REPORT OF THE
INDEPENDENT TECHNICAL
REVIEW
COMMITTEE EVALUATION
OF THE MOS-1 PORTION OF THE LOS ANGELES
METRO RAIL PROJECT

January 3, 1985

FIGURE 1

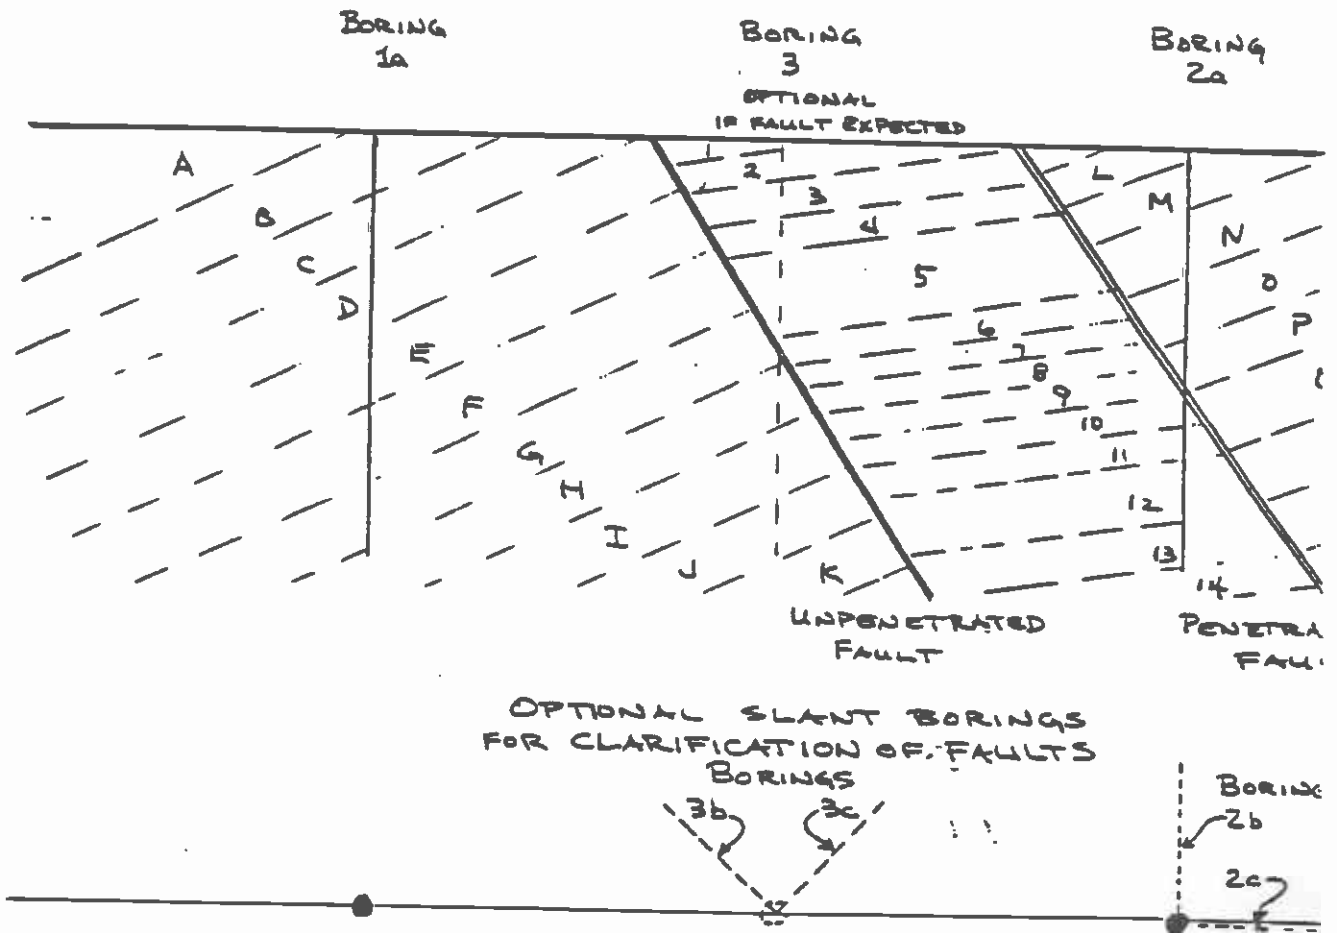
2. QUESTION BY J. SLOSSON:

In those instances where it is not practical to map geology inside the tunnel, cored holes could be used in advance of tunneling as shown in Figure 1 to pinpoint discontinuities.

FIGURE 2

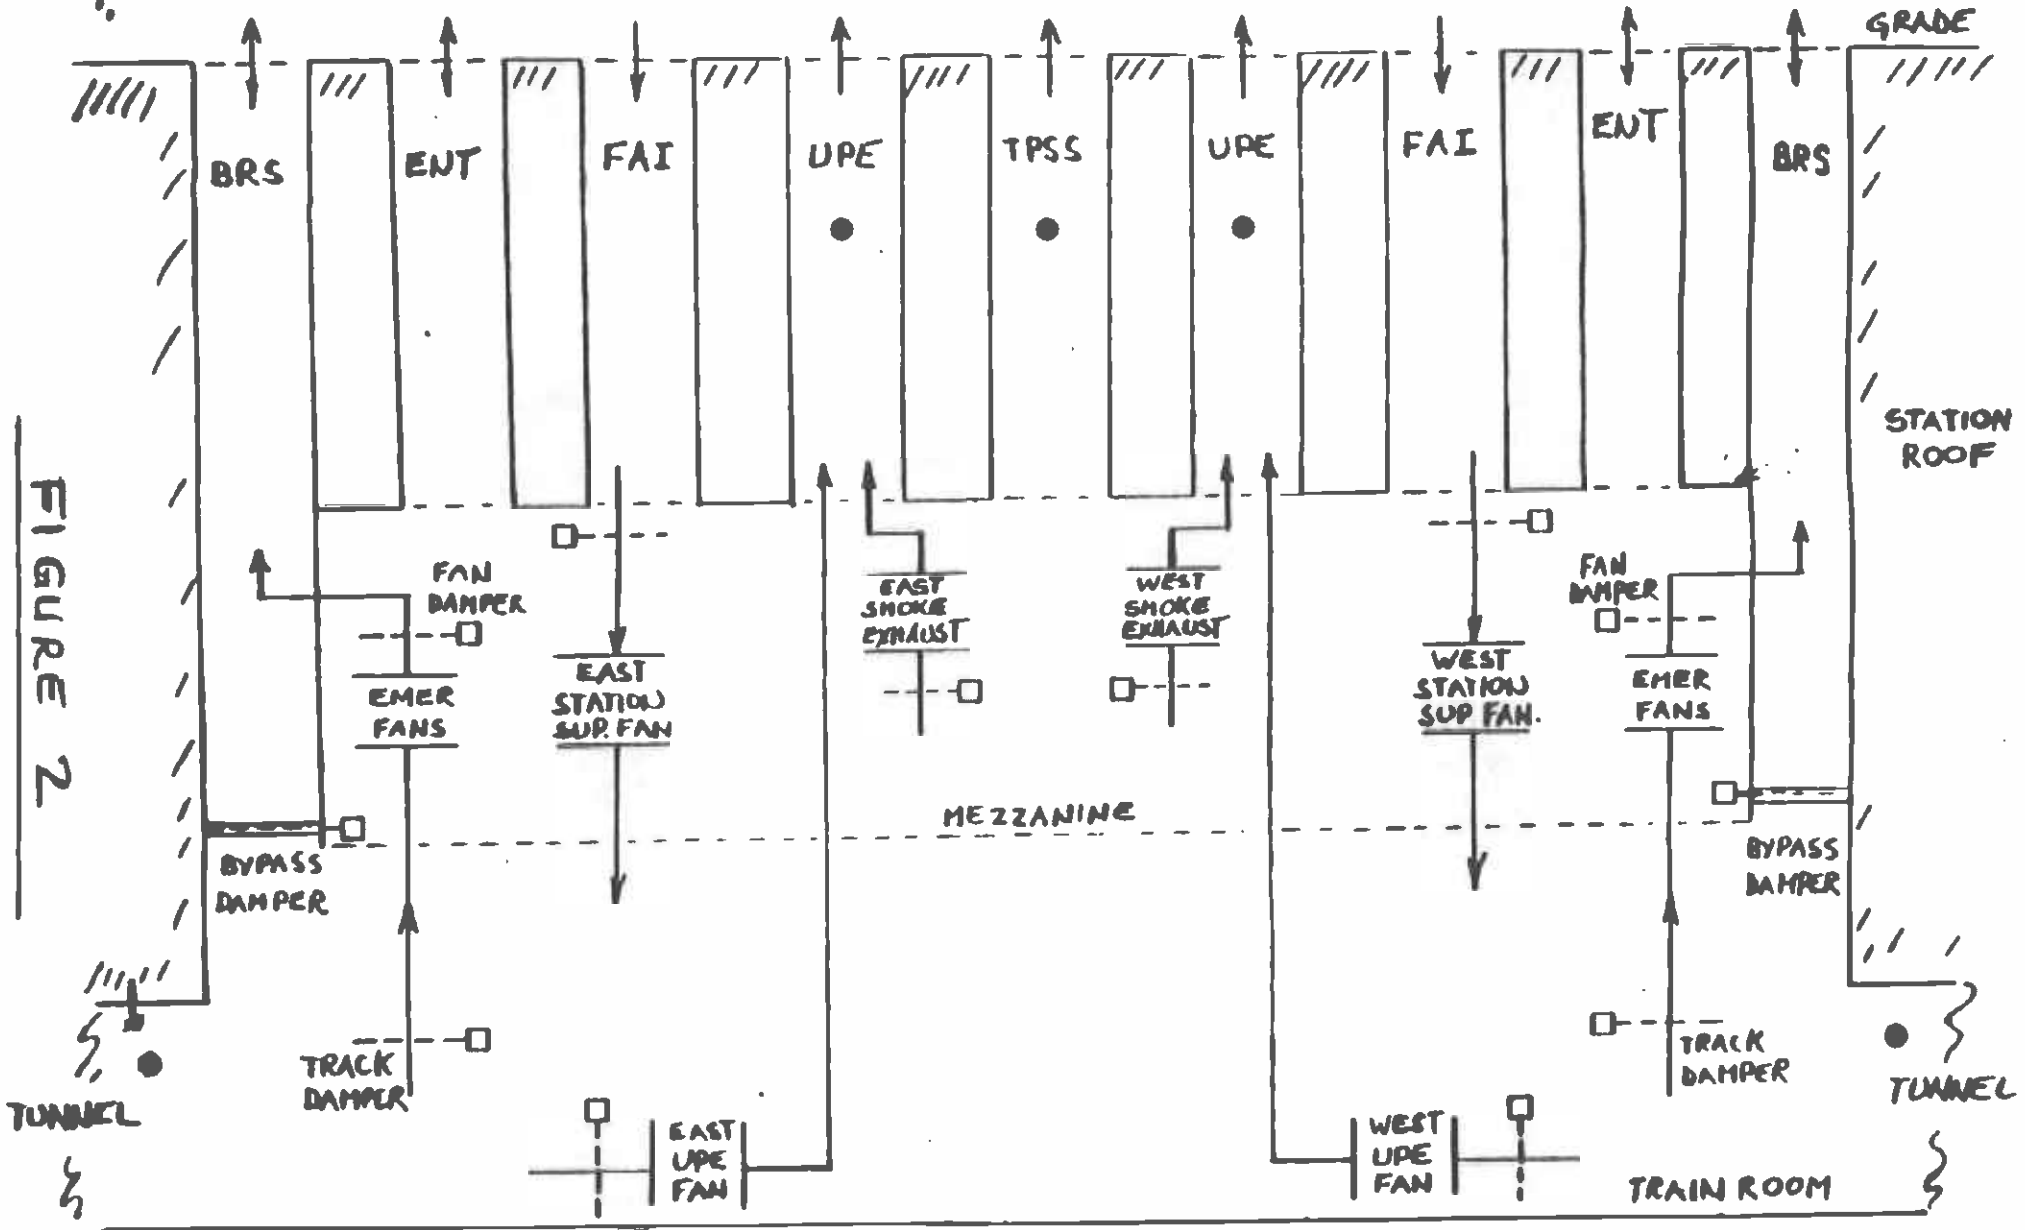
PART (C) Please clarify the alerts to be given control room operators - clearly specify if multiple warnings or alerts will be sounded and describe the concentration levels of gas that will trigger the "low", "moderate" and "high" or other "warnings" or "alerts".

Actions to be taken in the event of alarm level gas concentrations are displayed to the central control operator from the Metro Rail computer. The operator will review the proposed actions and initiate them by acknowledging to the computer that he is in agreement. The computer will then control the specific operations, i.e., starting fans, closing dampers, etc. If the central control operator does not agree with the proposed actions, he can modify those actions. Before the alarm level gas concentration is reached, plans include utilizing portable gas detection units to survey
